SPACE VILLAGE FILING NO. 4
A PORTION OF THE NW 1/4 OF SEC. 17, T14S,
R65W, OF THE 6th P.M., EL PASO COUNTY, COLORADO
GRADING & EROSION CONTROL PLAN

ASBUILT

ASBUILT NOTE

SHEET TITLE:
DETENTION POND PLAN

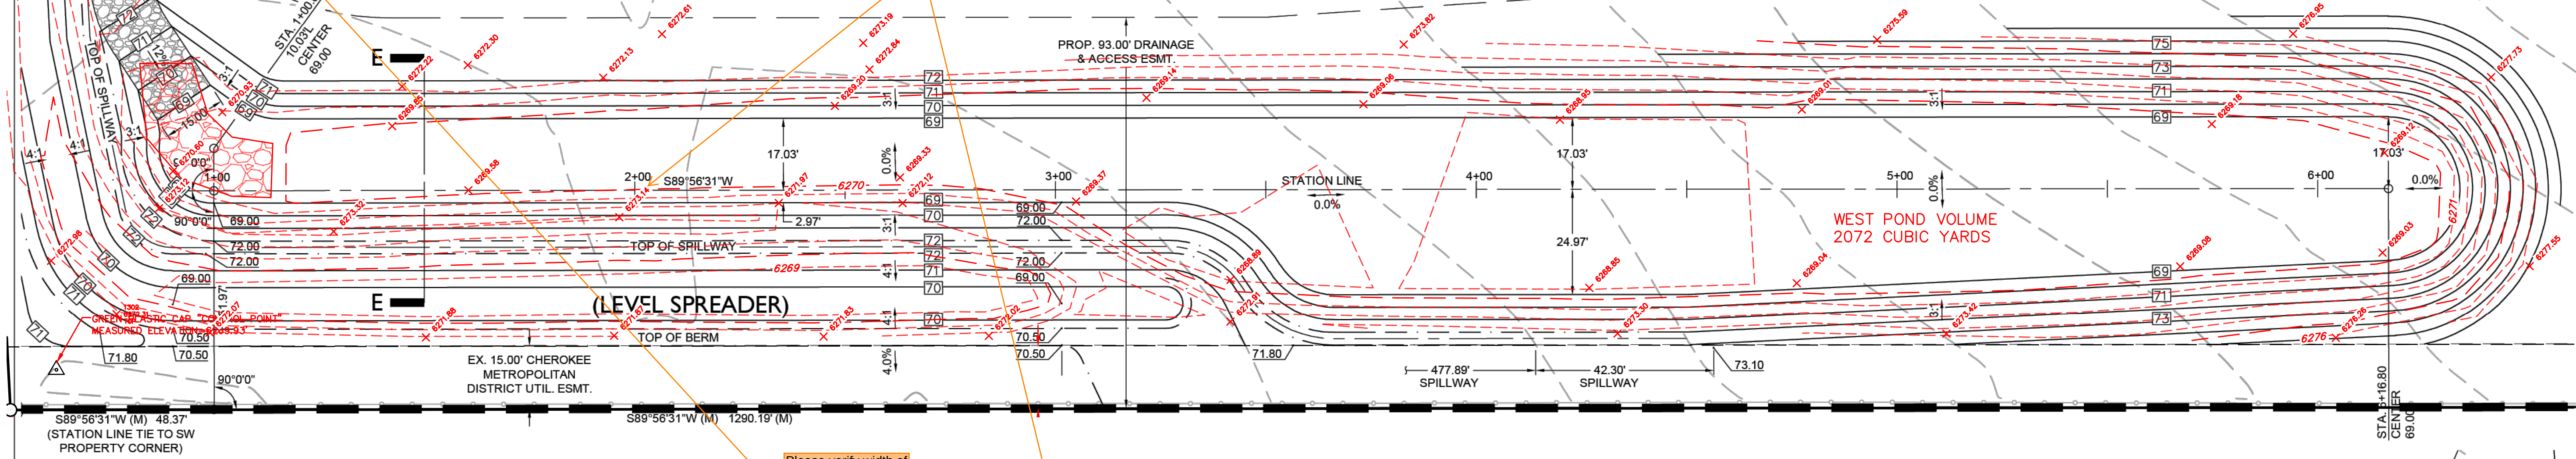
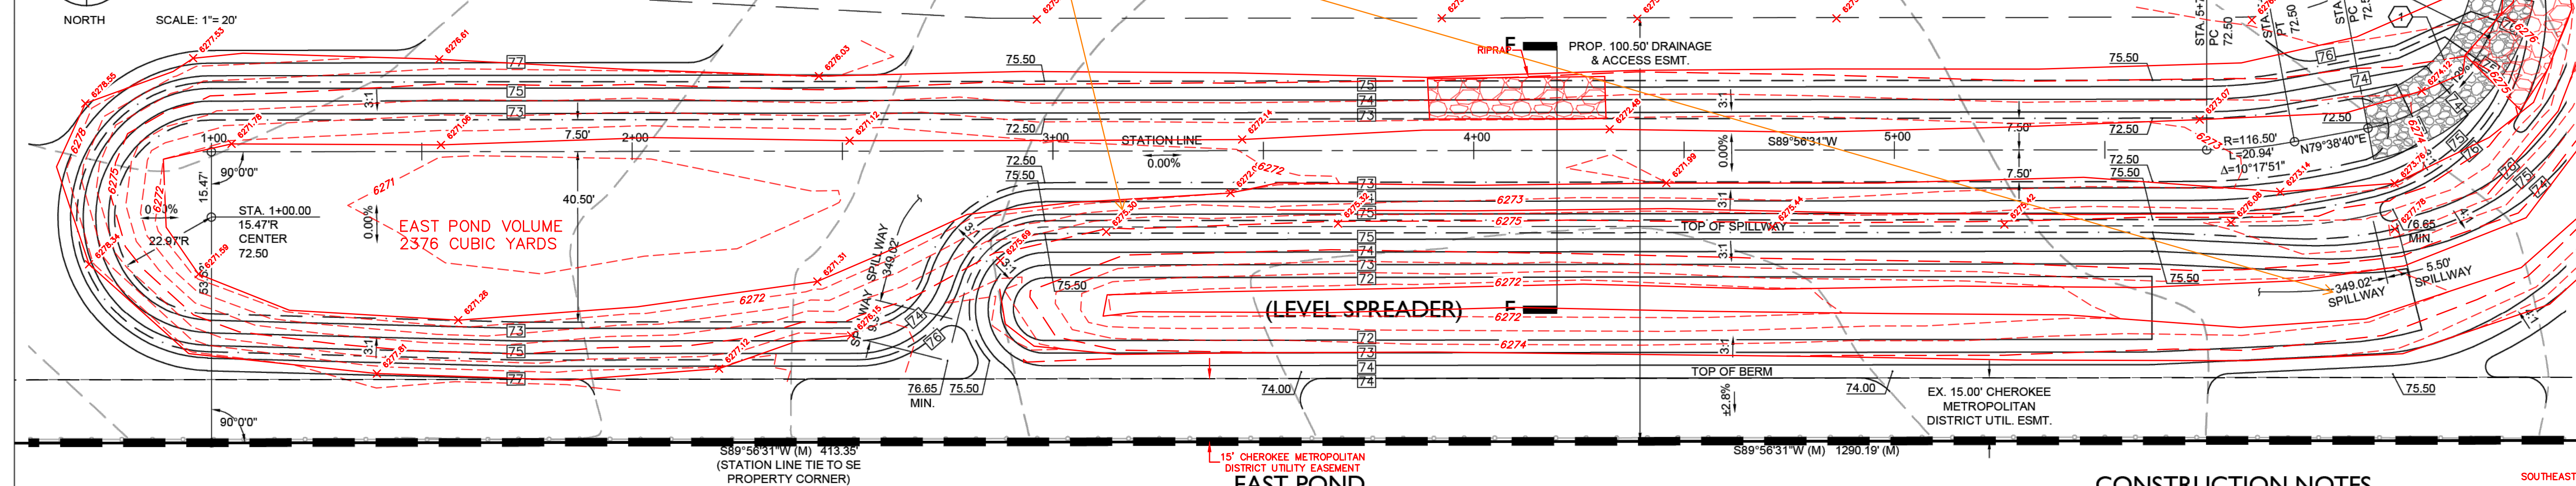
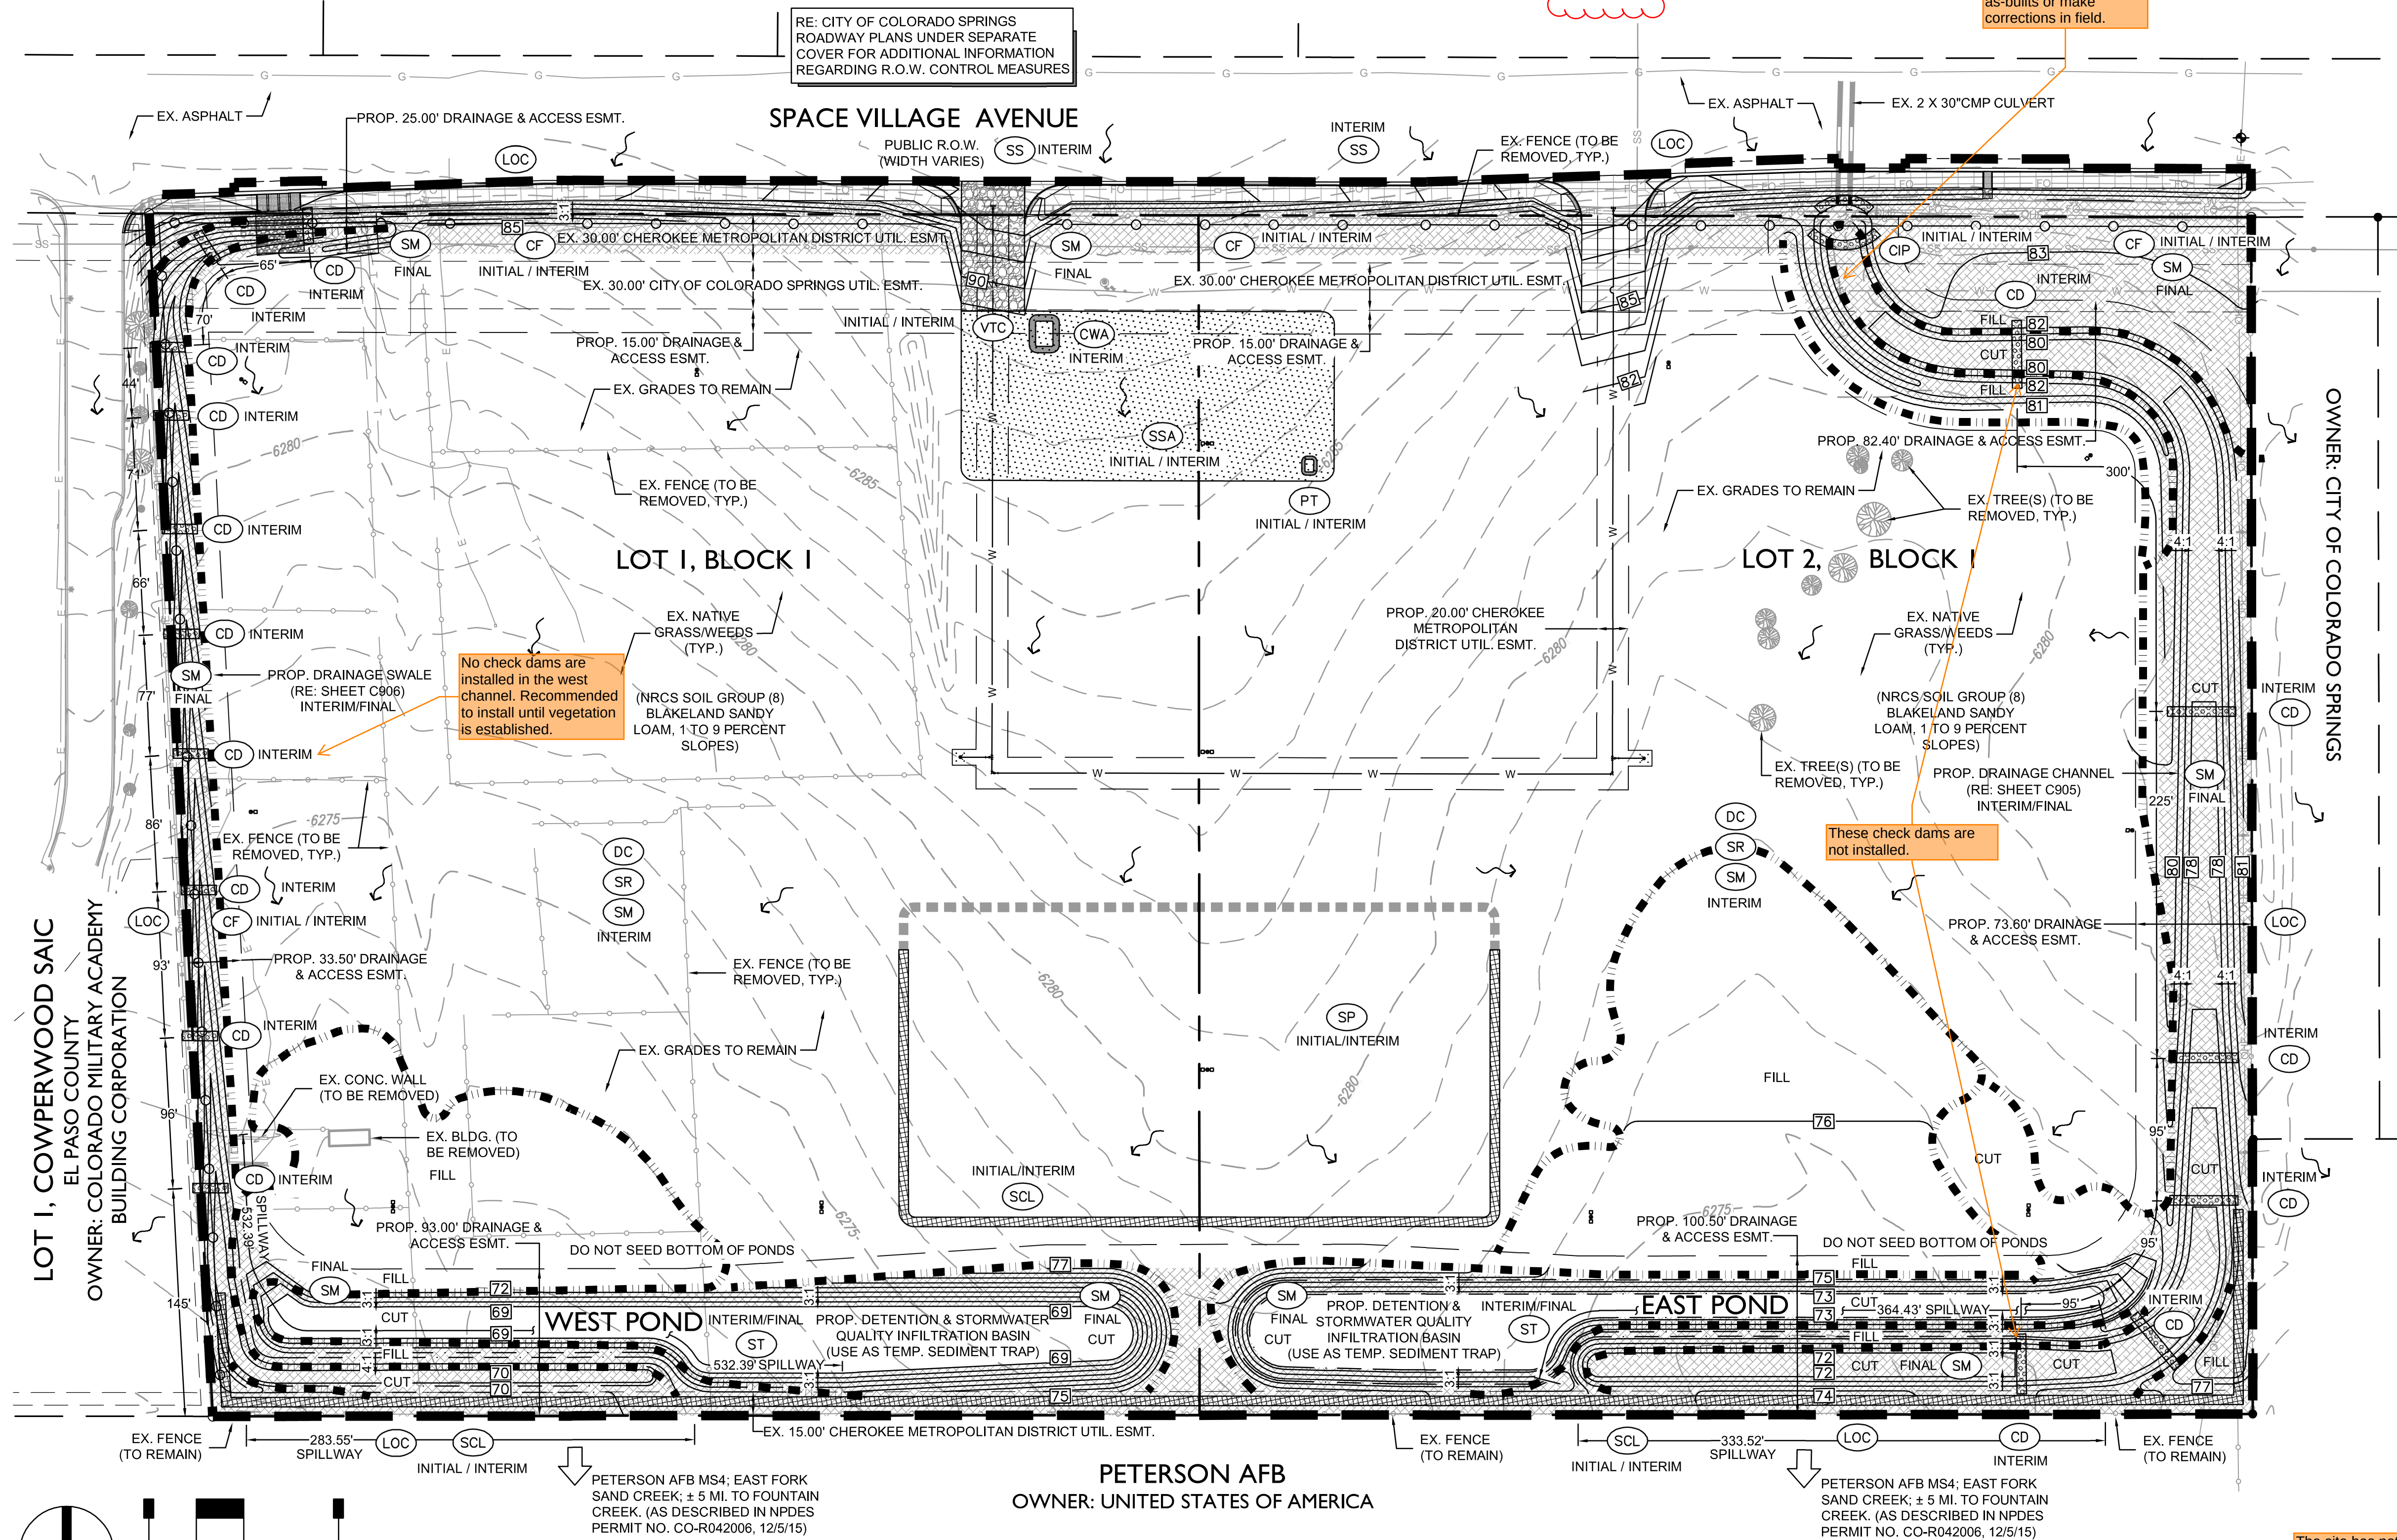
Elevations on pond plan view and spillway detail appear to conflict. Could you clarify where the elevations on the detail are from?
